CORRIGENDUM- 01

PROJECT	:	1X660 MW UPRVUNL PANKI EXTN
PACKAGE	:	EFFLUENT TREATMENT PLANT
ENQUIRY NO	:	PE/PG/PKI/E-6311/2019 Dated. 05.10.2019
SUBJECT	:	TECHNICAL AMENDMENT

AMENDMENT ON TECHNICAL SPECIFICATION
FOR
EFFLUENT TREATMENT PLANT (ETP)
1X660 MW PANKI THERMAL POWER STATION

SPECIFICATION NO.: PE-TS-426-164-A001
AMENDMENT NO # 1
REV. NO. 00 DATE: 22/10/2019
Page 1 of 3

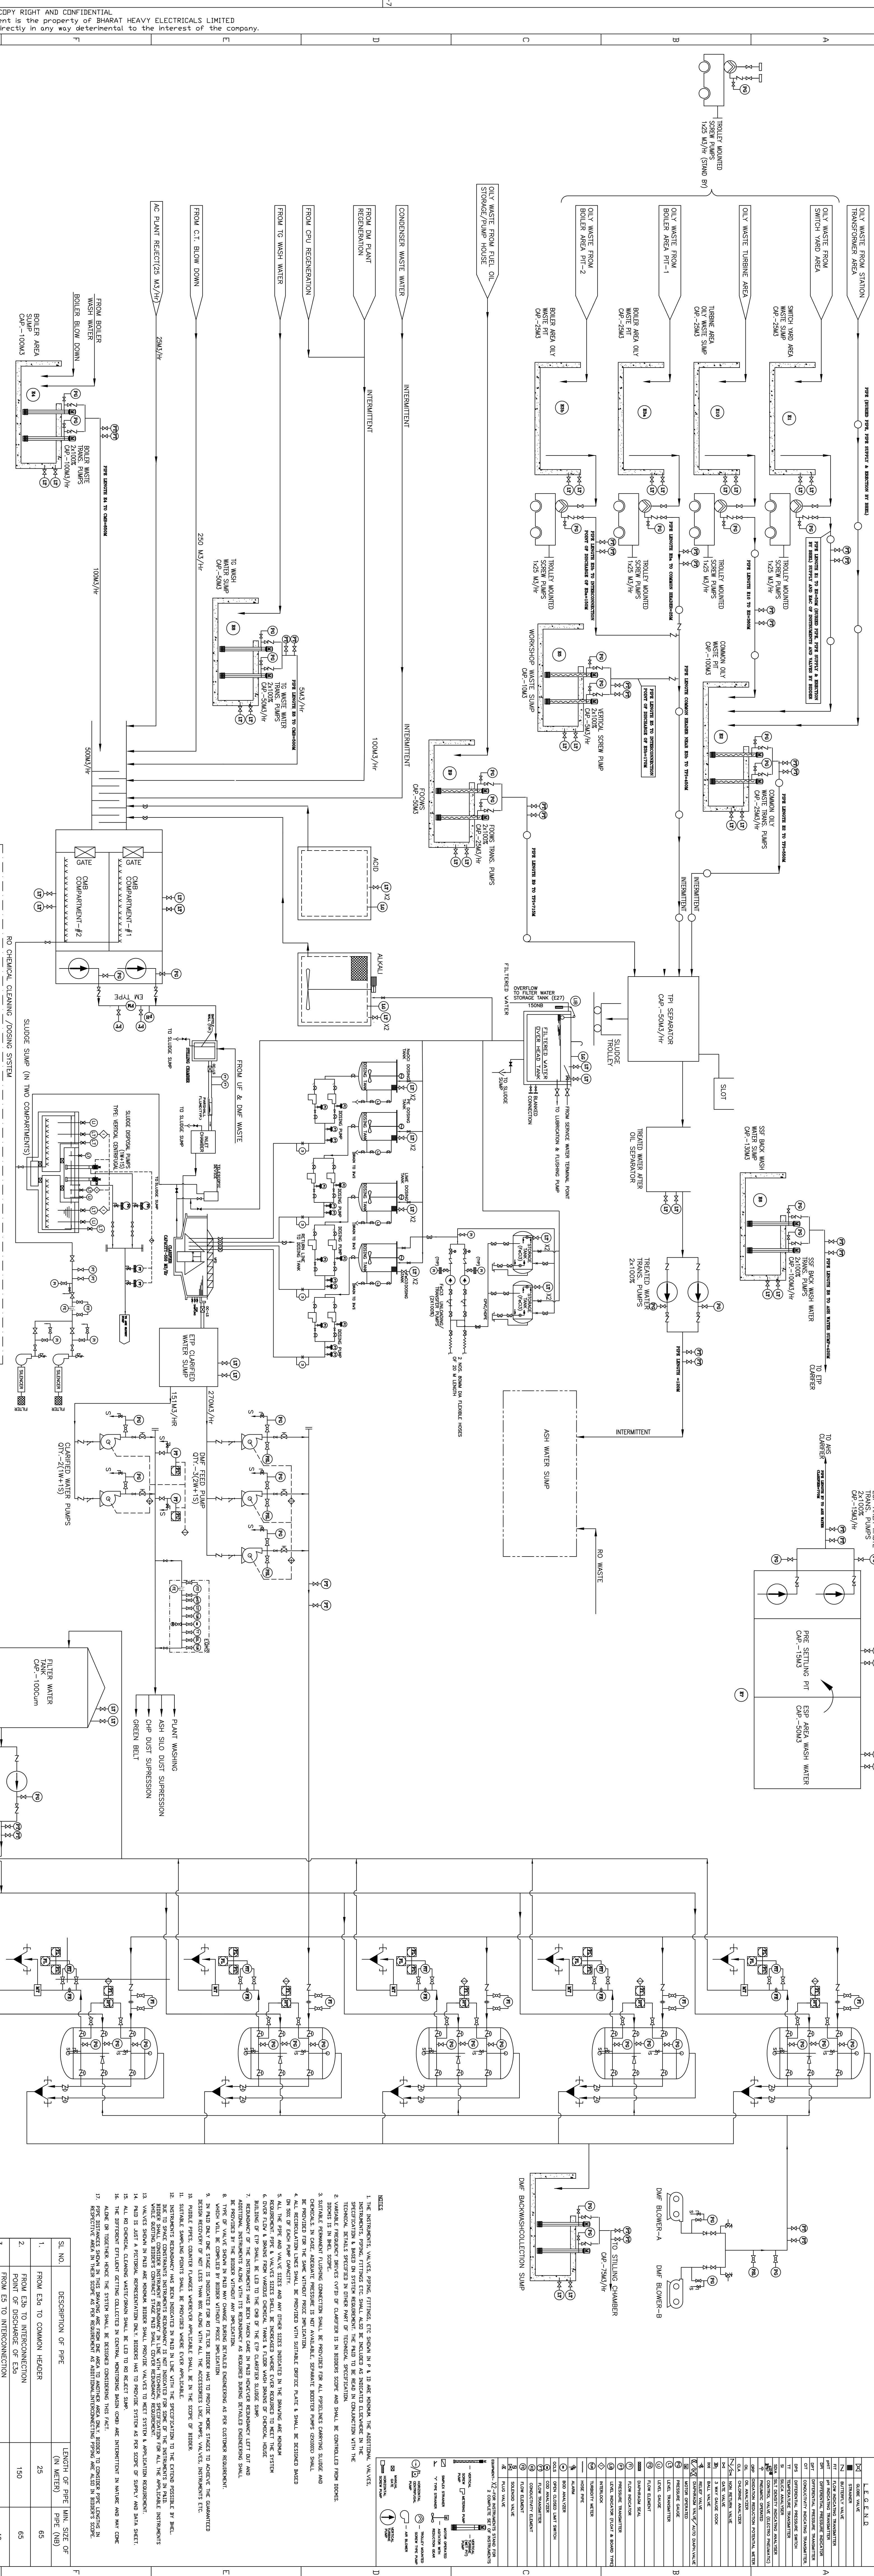
Sl no.	Vol. No.	Section/ Description	Clause no	Page no	Existing clause/details	Modified clause/details
1.	IIB	SECTION- C1	Drawings	112 of 519	P&ID FOR EFFLUENT TREATMENT PLANT -DRAWING NO.-PE-DG-426-164-A001, REV-0	P&ID FOR EFFLUENT TREATMENT PLANT - DRAWING NO.-PE-DG-426-164-A001, REV-1 is applicable.

SL. NO	Interpretation of Pipe	Length of Pipe Max. Size of (in. Metric) (in. Metric)
1.	FROM ELS TO COMMON HEADER	25
2.	FROM ELS TO INTERCONNECTION	65
3.	FROM ELS TO DISCHARGE OF ELS	150

NOTE: PIPE DIAMETER/SIZE MENTIONED IS MINIMUM TO BE FOLLOWED BY BIDDER. HOWEVER IF ANY HIGHER SIZE OF PIPE IS REQUIRED SAME SHALL BE PART OF BIDDER'S SCOPE WITHOUT ANY IMPLICATION TO BHEL.
